**Section 16 Planning Application for Proposed Commercial Use at Phase IIa Development of an Approved Master Layout Plan (MLP) with Minor Relaxation of Plot Ratio Restriction (Proposed Amendments to the Approved MLP for Comprehensive Residential, Commercial, Social Welfare Facility and Public Vehicle Park Development; with Minor Relaxation of Plot Ratio Restriction Approved at Phase III) at Lot Nos. 461 RP, 462 S.B, 463 S.B, 464 RP, 495 RP and 539 S.B in D.D. 116, Yuen Long Town Lot (Y.L.T.L.) 504, Y.L.T.L. 544 (Part) and Adjoining Government Land, Yuen Long, New Territories
(Application No. A/YL/333)**

1. Drainage Services Department	Page	1
2. Planning Department – District Planning Office	Page	2
3. Planning Department – Urban Design and Landscape	Page	4
4. Transport Department	Page	7
5. Environmental Protection Department	Page	7

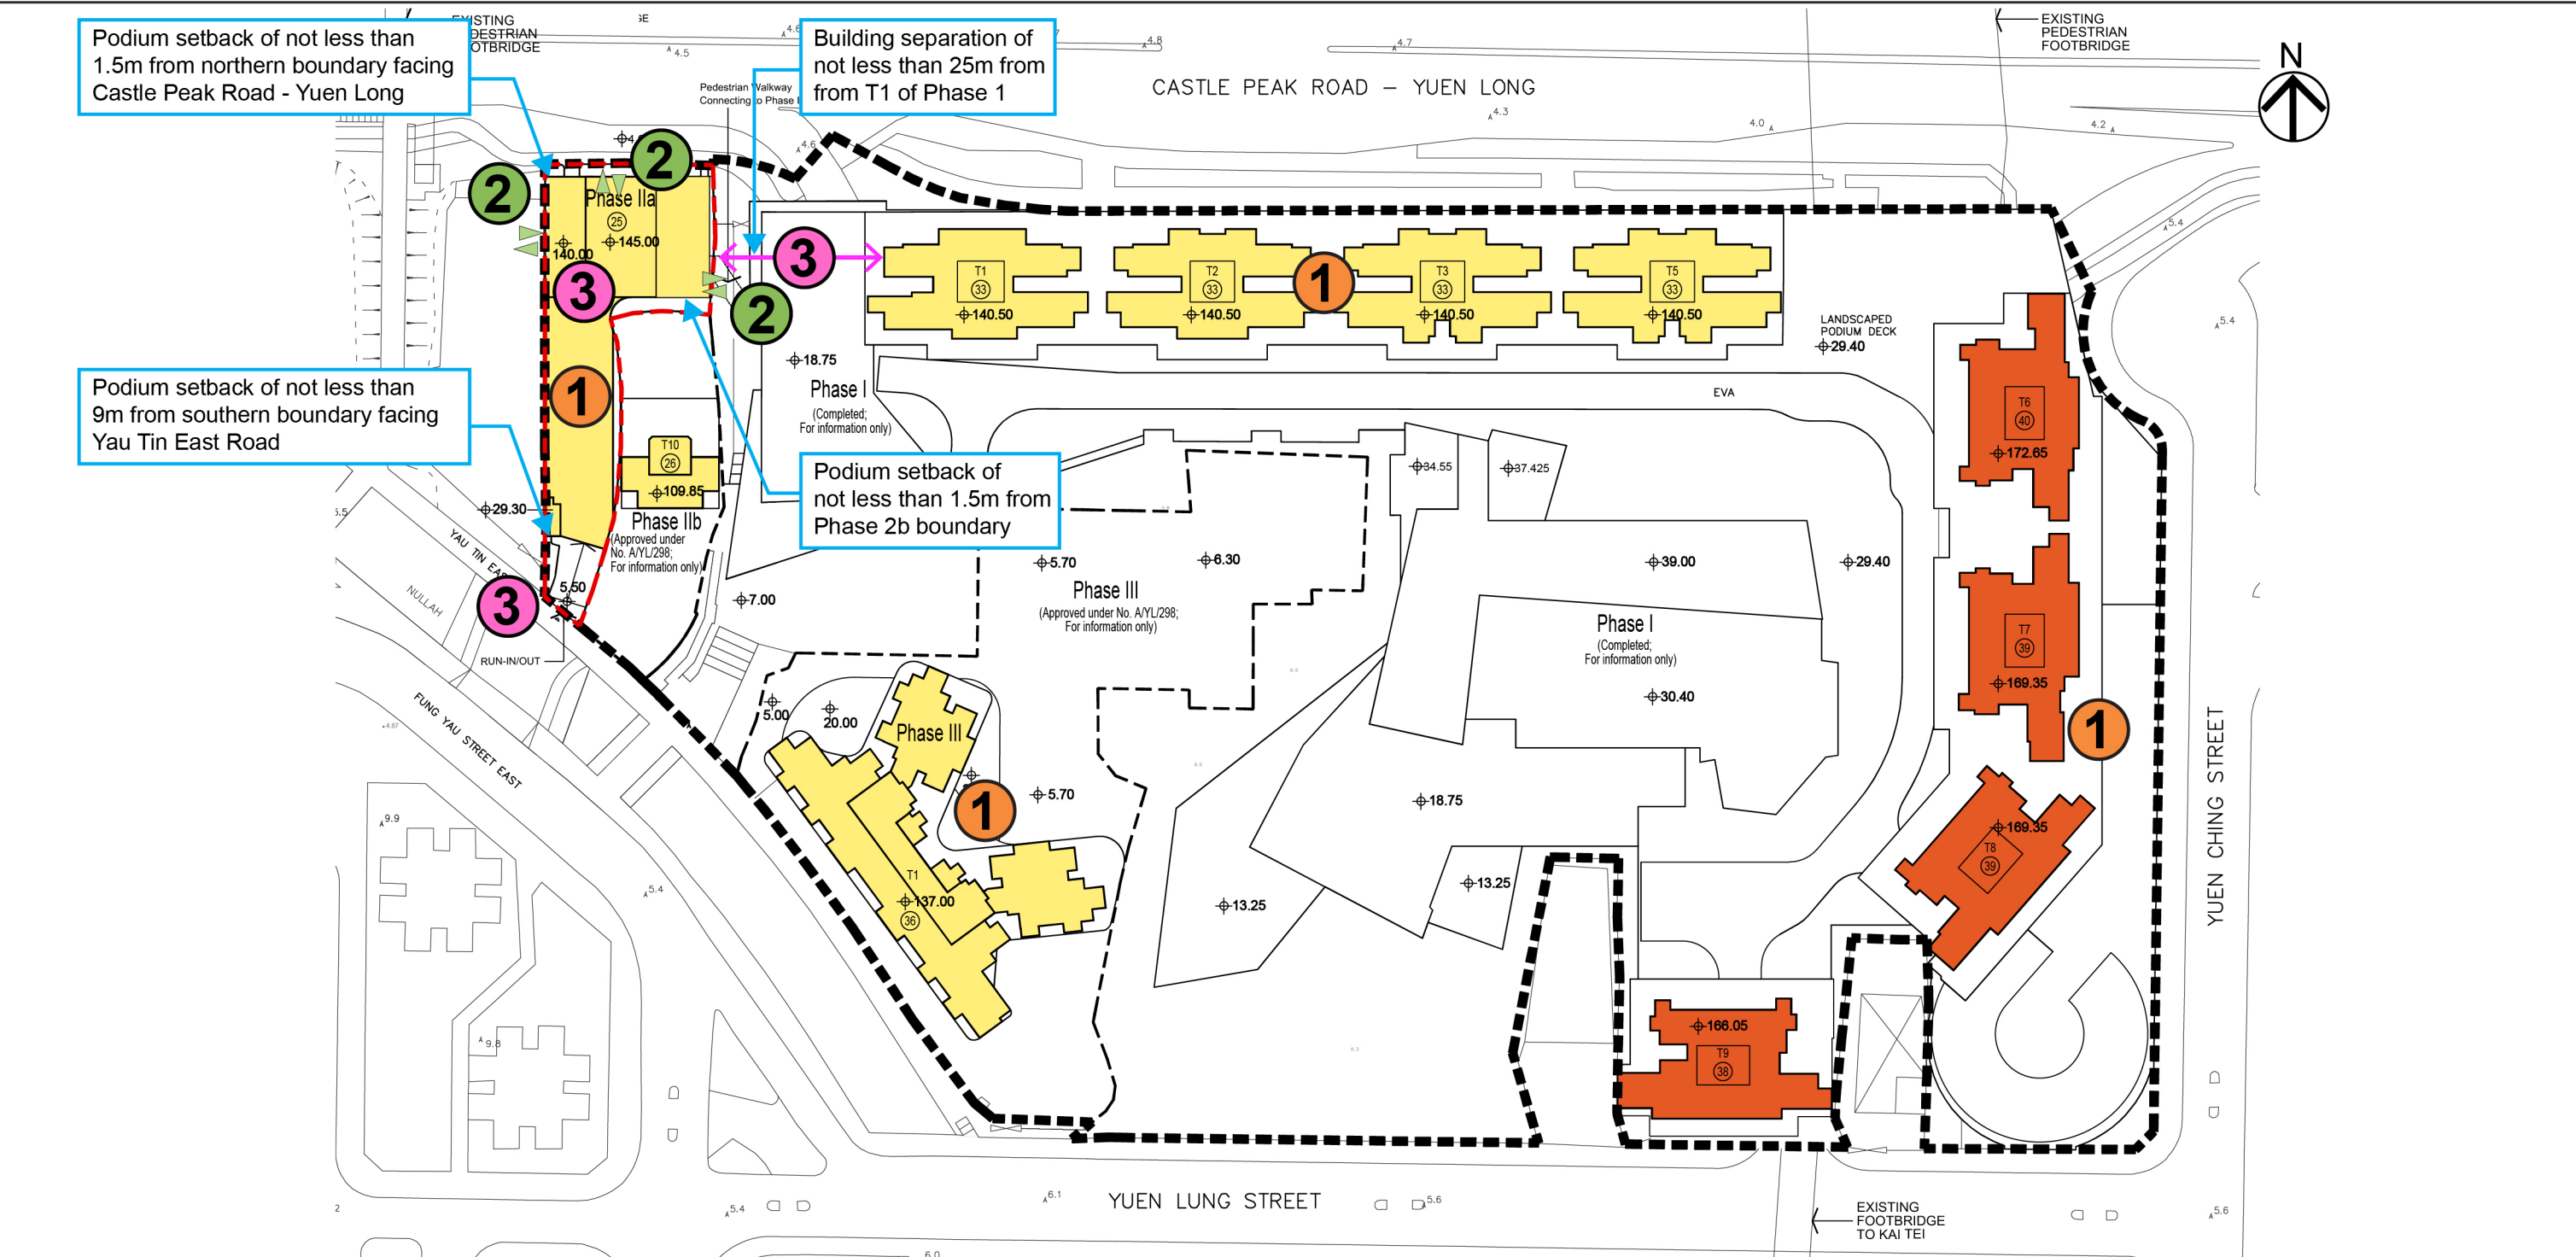
3.3.2	(ii) with reference to the site photos taken by DPO on 10.6.2026, the Site was formed, some temporary structures and existing trees were found within the Site;	Noted.
